## Market Change Request

Number		Title	Priority
<b>MCR</b>	<b>0156</b>	Amending Generator Unit ID and Generation Unit ID	<i>High</i>

CHANGE REQUEST:		
<b>Name of Requesting Organisation</b>	RMDS	
<b>Contact name</b>	Richard Bloomfield	
<b>Date Change Request Raised</b>	19 <sup>th</sup> October 2007	<b>Originating Discussion Request</b>
		<b>DR</b> 0151

Detailed changes for new process MPD 16 (2.1) – Data Aggregation:-

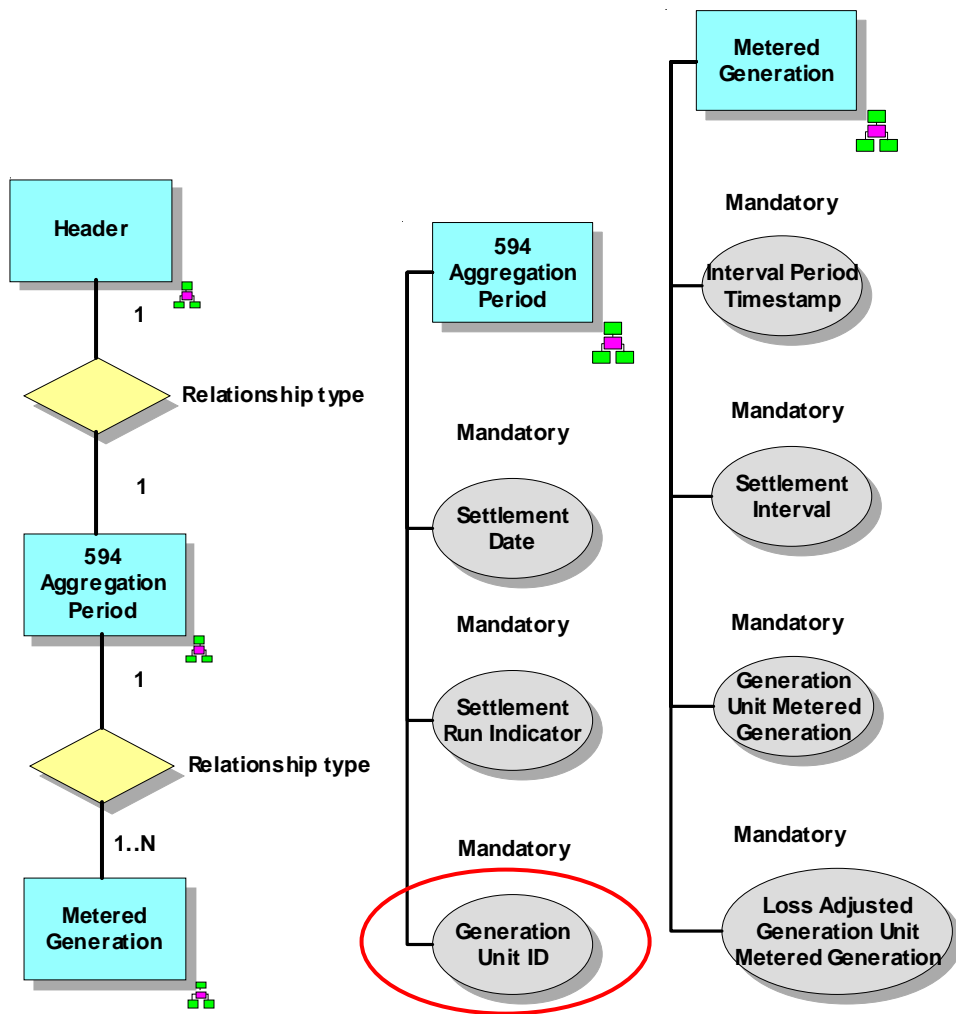
New functions and events will be added to create a new process MPD 16 (2.1).

MM 597

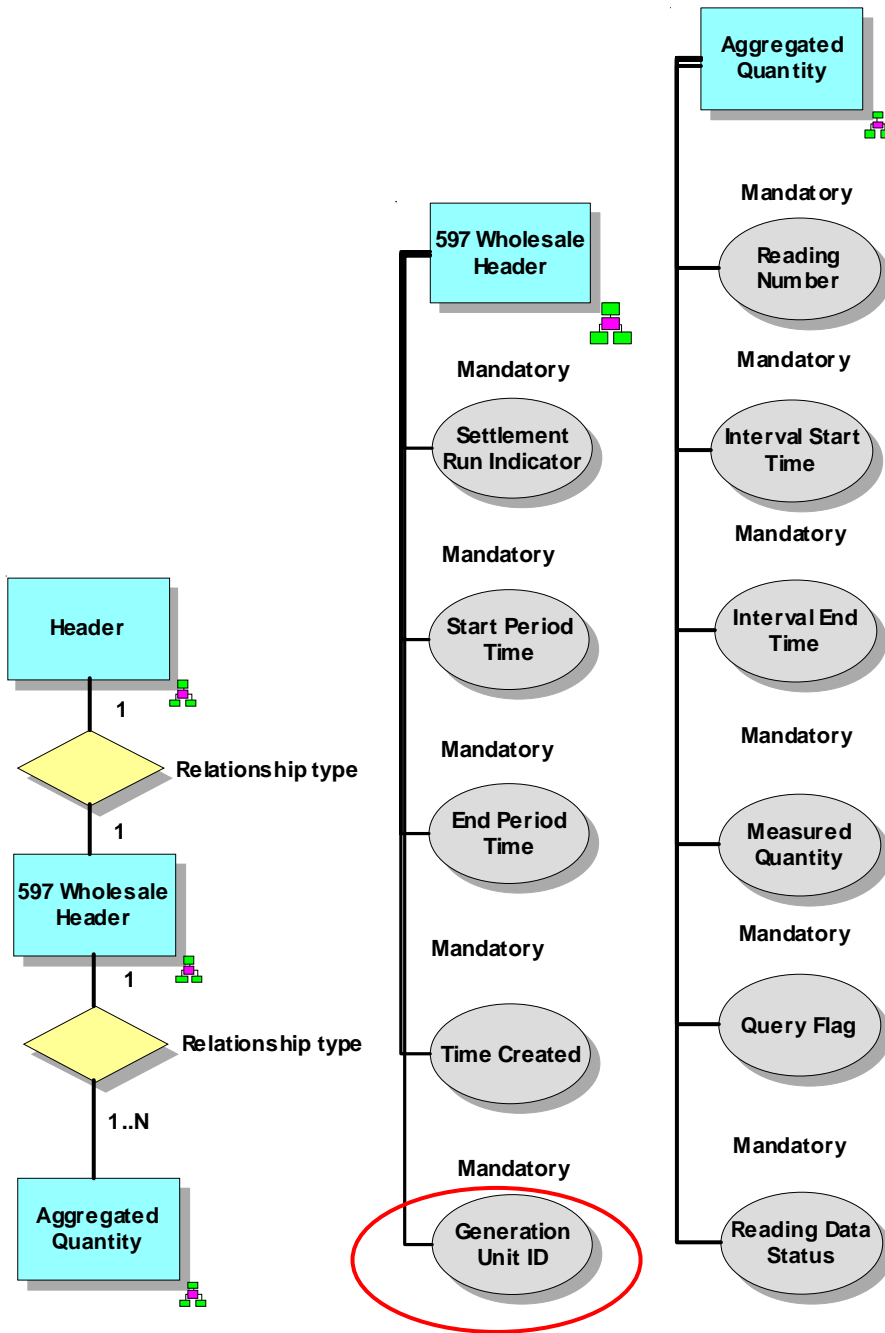
**Note: Details of new Data Items and Definitions (i.e. ~~Supplier Unit ID, Generator Unit ID~~) can be**

found in MCR 120.
